VALUE ENGINEERING WORKSHOP REPORT (DRAFT)
for:
Florida Department of Transportation

South Sumter Trail
FPN: #435471-1

**RE: Value Engineering Study Report (Draft)
South Sumter Trail
FPN: #435471-1**

PROJECT:	South Sumter Trail FPN #: 435471-1	ALTERNATIVE NO.: SA-11
DESCRIPTION:	Use Reduced Width Ditch Bottoms	SHEET NO.: 3 of 5

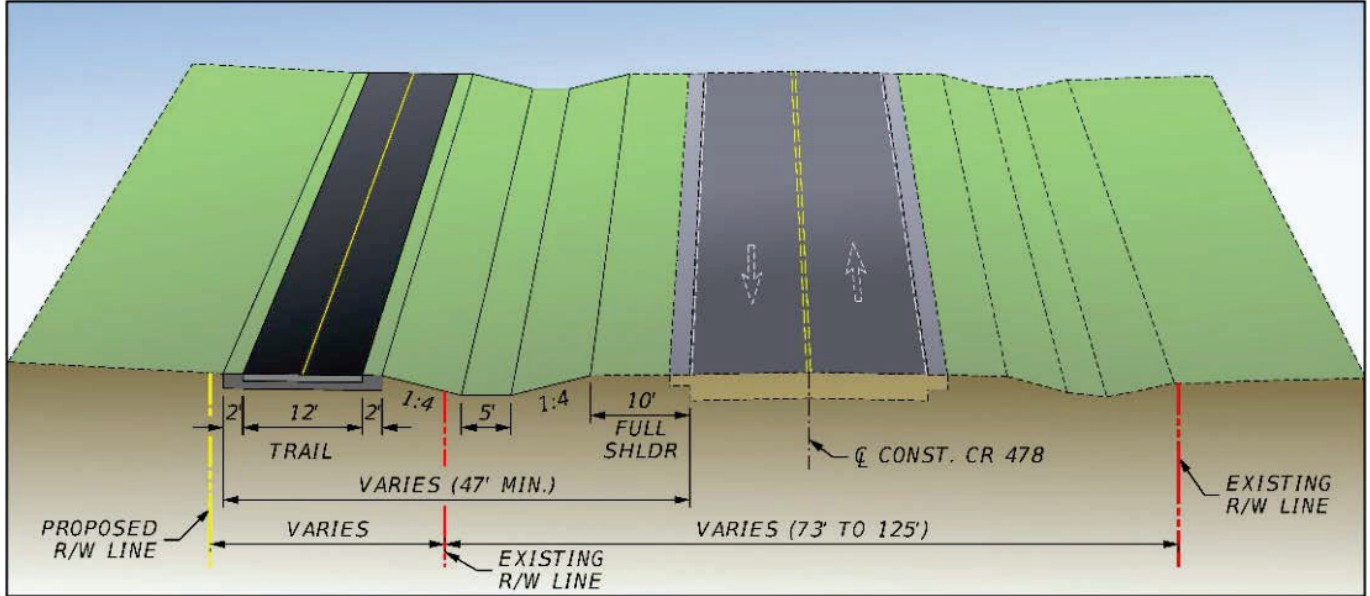
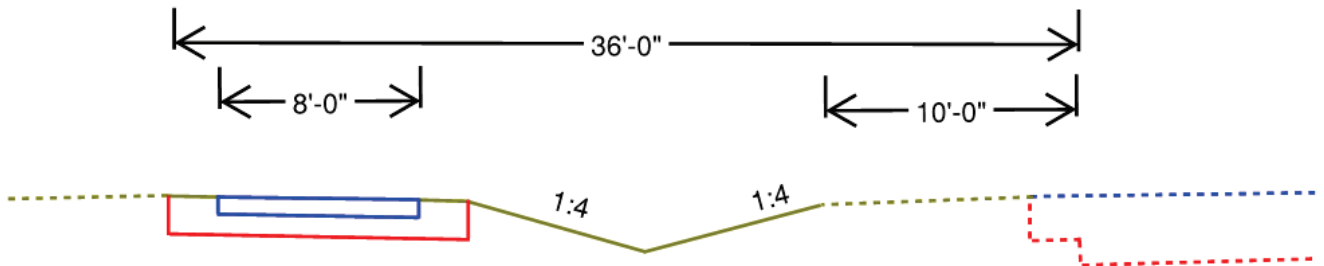
- **HARDER TO MAINTAIN.**
- **REDUCED HYDRAULIC CAPACITY.**
- **ADDITIONAL PLAN DETAILS.**

PROJECT:	South Sumter Trail FPN #: 435471-1	ALTERNATIVE NO.: SA-13
DESCRIPTION:	Vary Trail Width Based On ROW (8' – 12')	SHEET NO.: 3 of 4

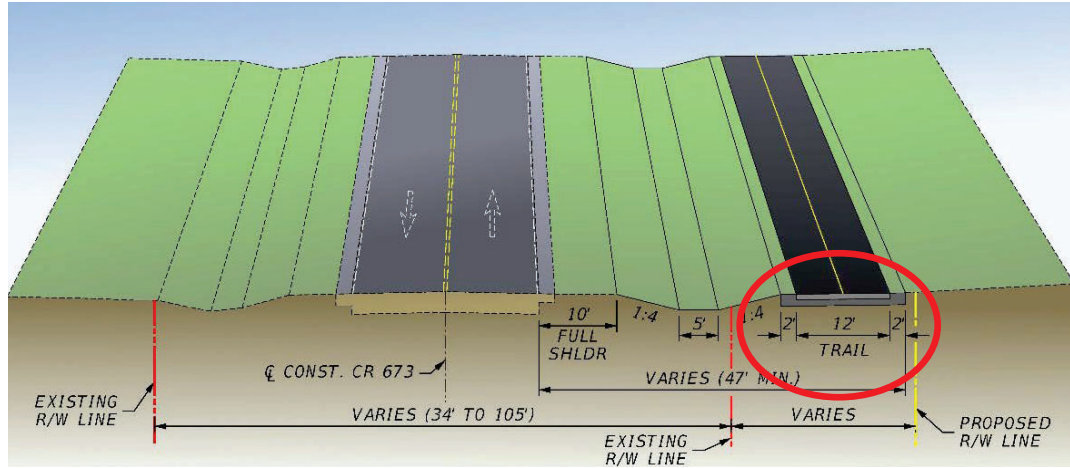
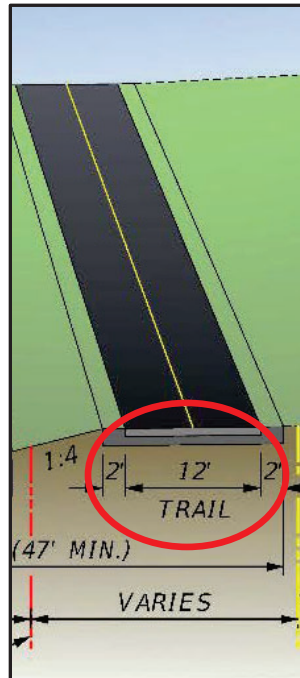
At locations where 12' can be fitted in an existing ROW or an augmented ROW, that would be the preferred option. At other places where drainage or options to expand the right of way are not available the ability to adjust paved surface should be an option for the designer. Transitions from 12' to a minimum width of 8' should be allowed after consultation with the Chief Planner based on conditions.

**Trail width options in order of preference:
11', 10', 9', 8' (min)**

PROJECT:	South Sumter Trail FPN #: 435471-1	ALTERNATIVE NO.: SA-21
DESCRIPTION:	Build Double Ditch	SHEET NO.: 3 of 5

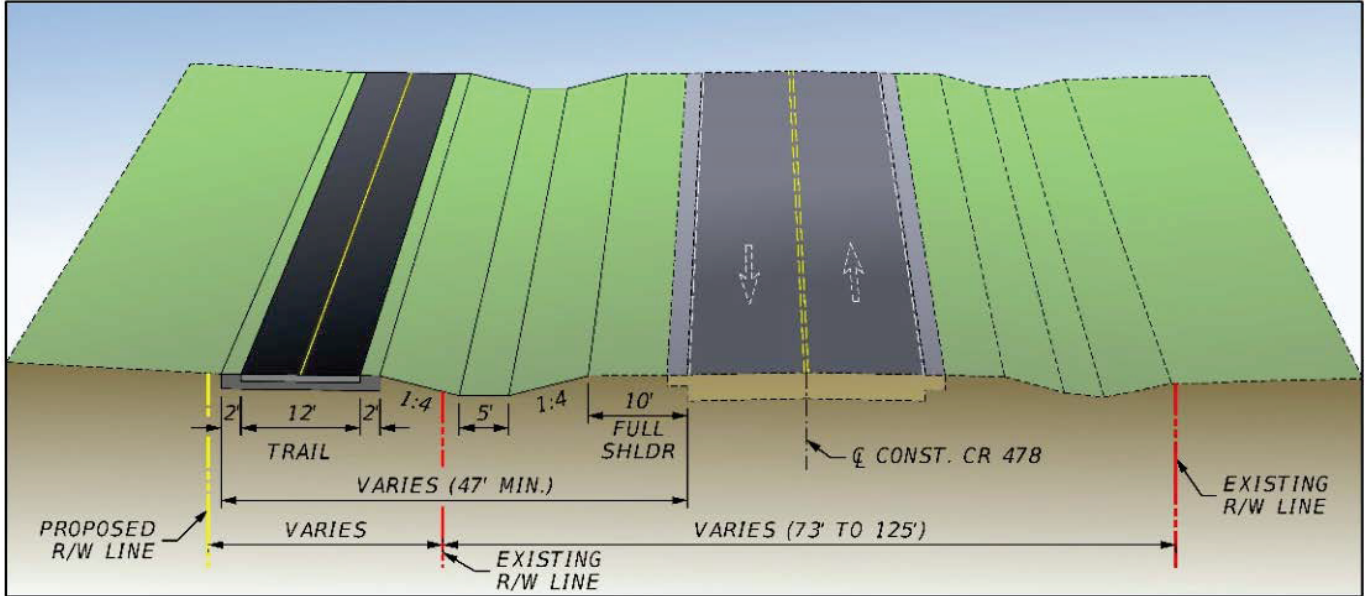
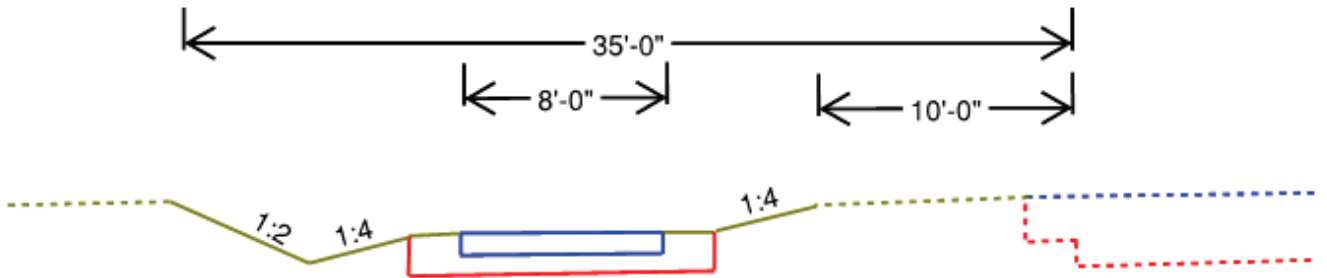
ALTERNATIVE:

PROJECT:	South Sumter Trail FPN #: 435471-1	ALTERNATIVE NO.: S1-03
DESCRIPTION:	Cross River At Iron Bridge Location	SHEET NO.: 2 of 2

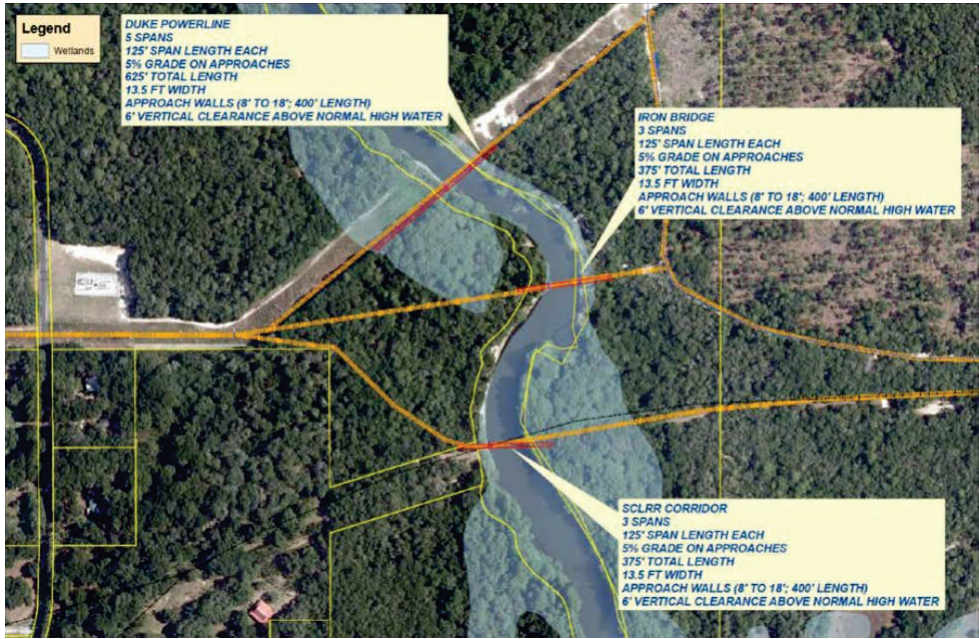
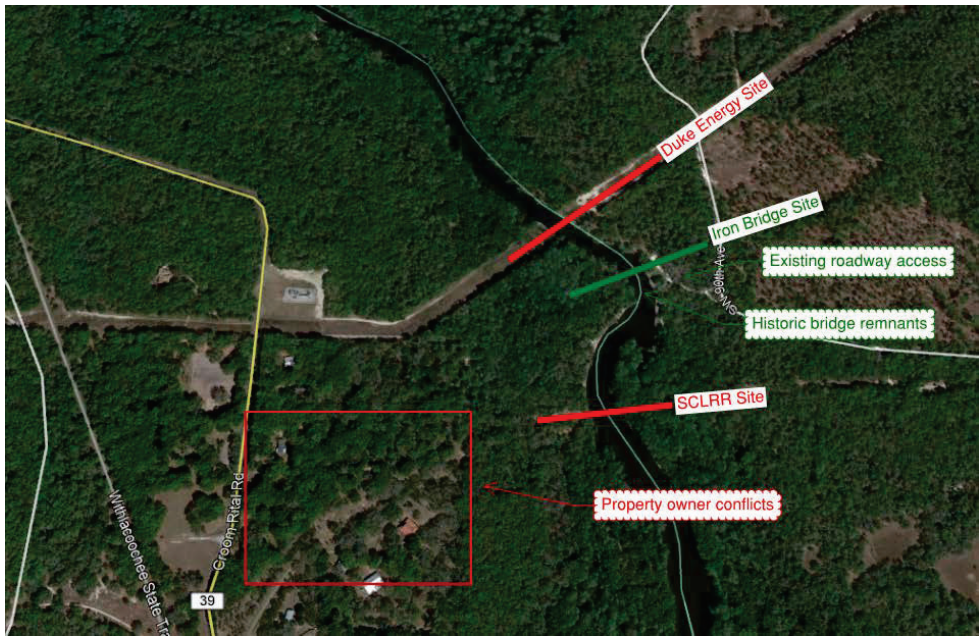
ALTERNATIVE:

PROJECT:	South Sumter Trail FPN #: 435471-1	ALTERNATIVE NO.: S1-15
DESCRIPTION:	Avoid Flood Plain Impacts Or Compensate With Cut Adjacent To Trail	SHEET NO.: 3 of 5

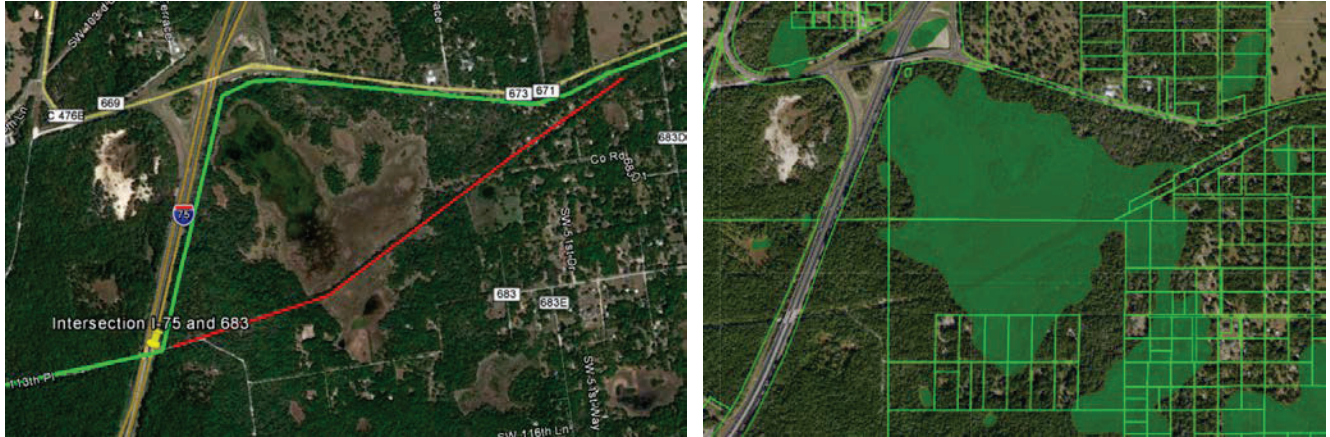
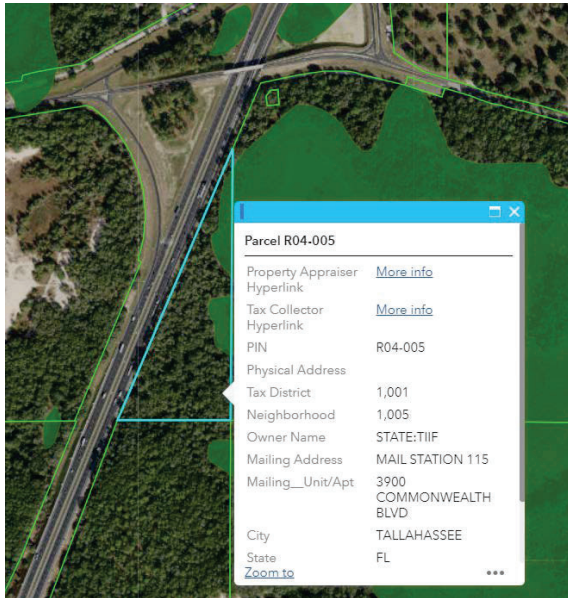
Trail alignment options shown as green and red lines in the map on the left.

Highlighted parcel is owned by the forest, and is hydraulically connected to the floodplain that will be impacted as the trail crosses the private property. This makes it a good site for compensation.

PROJECT:	South Sumter Trail FPN #: 435471-1	ALTERNATIVE NO.: S1-23
DESCRIPTION:	Install Warning Lights At Quarry Driveway Entrances	SHEET NO.: 2 of 5

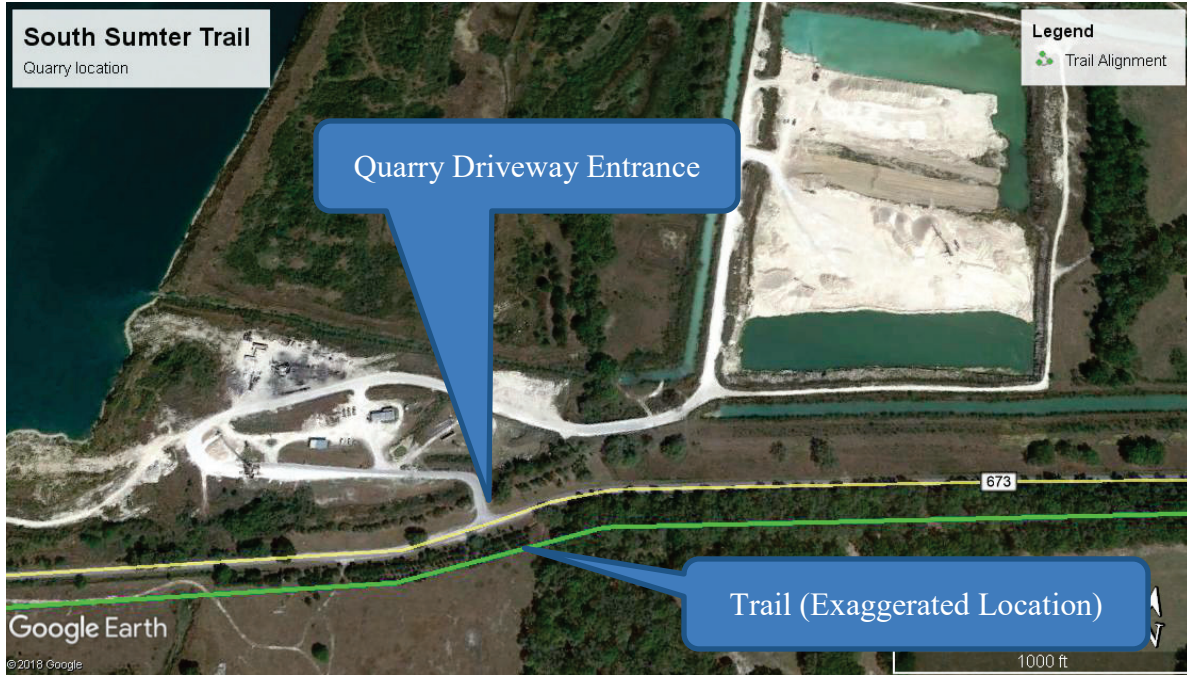
ALTERNATIVE: PLACE WARNING LIGHTS

PROJECT:	South Sumter Trail FPN #: 435471-1	ALTERNATIVE NO.: SA-18
DESCRIPTION:	Realign Trail Up to Webster / Back From SR 50	SHEET NO.: 2 of 2

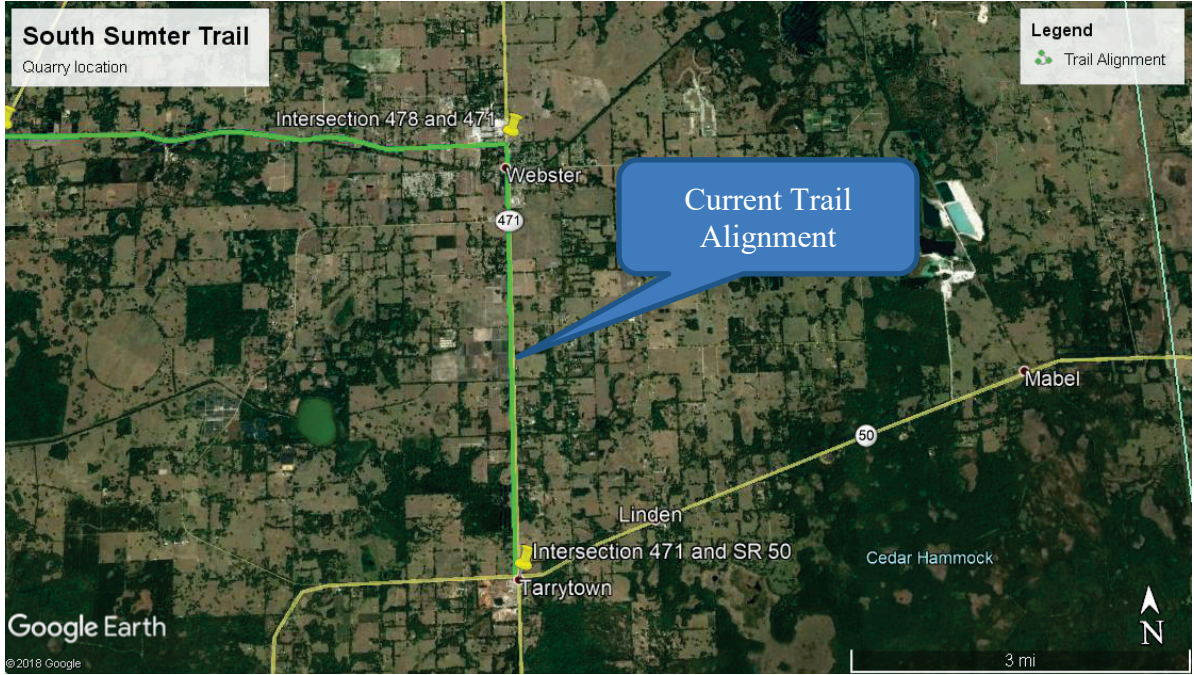
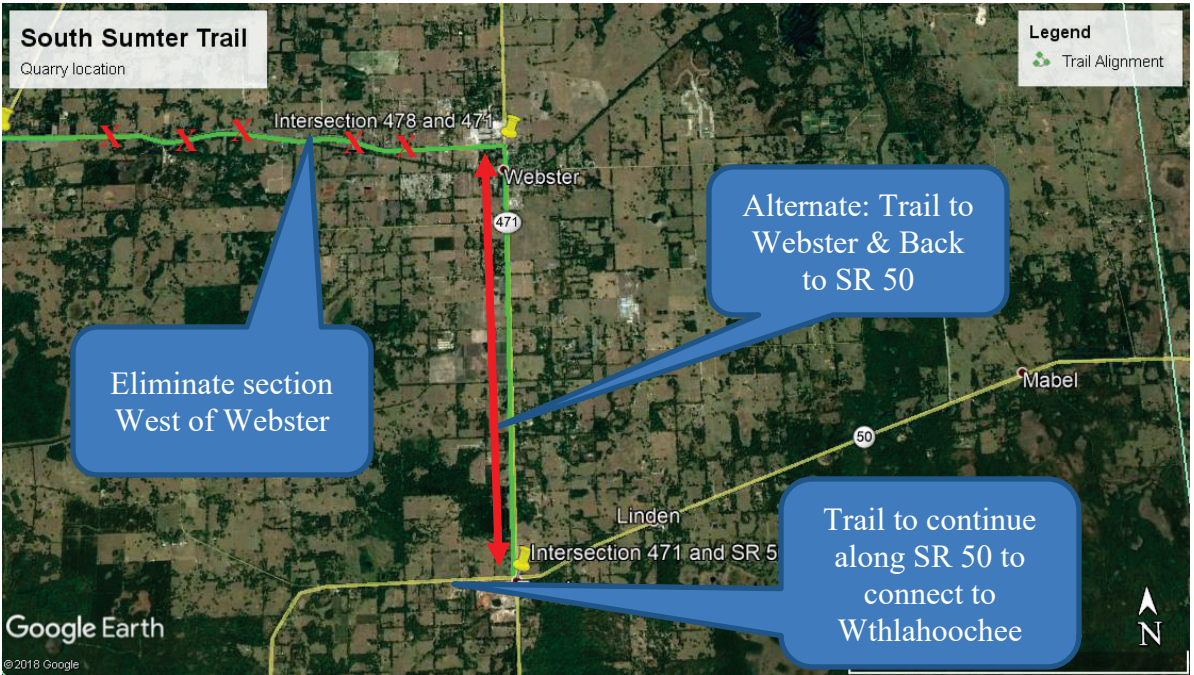
ALTERNATIVE:

PROJECT:	South Sumter Trail FPN #: 435471-1	ALTERNATIVE NO.: SA-22
DESCRIPTION:	Revisit ROW Proposed VS ROW Actually Required for Facilities	SHEET NO.: 2 of 2

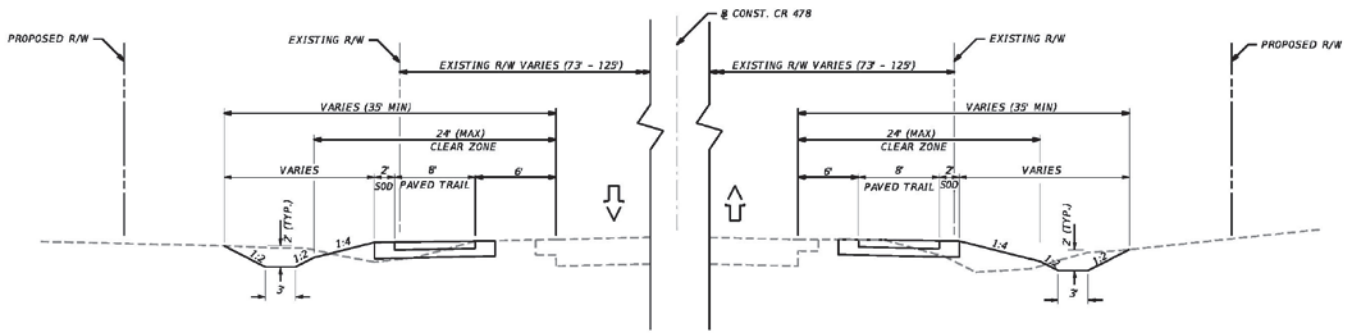
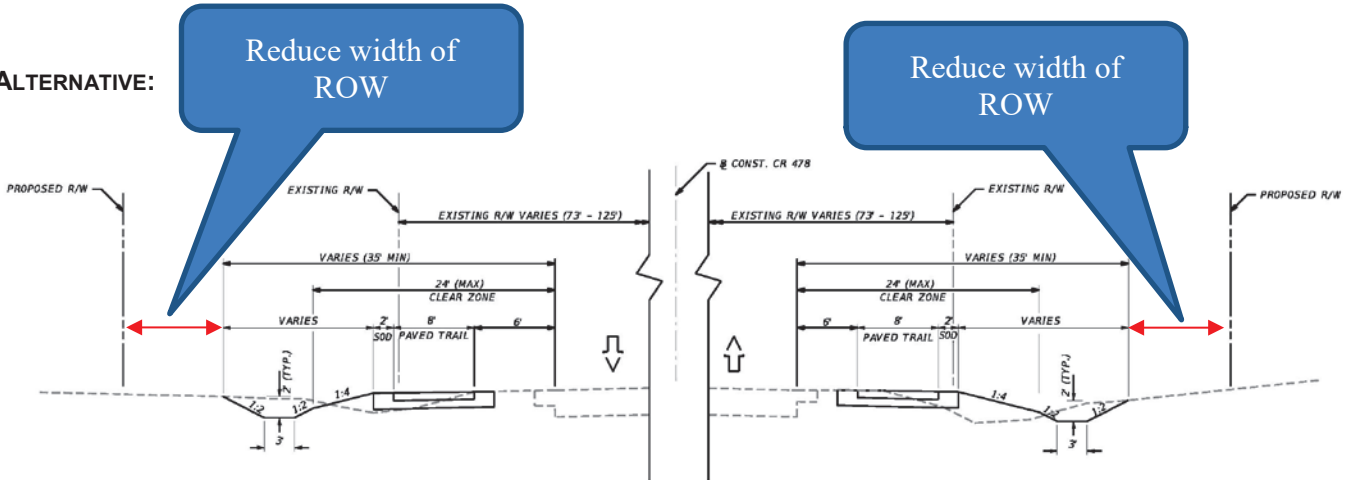
ALTERNATIVE:
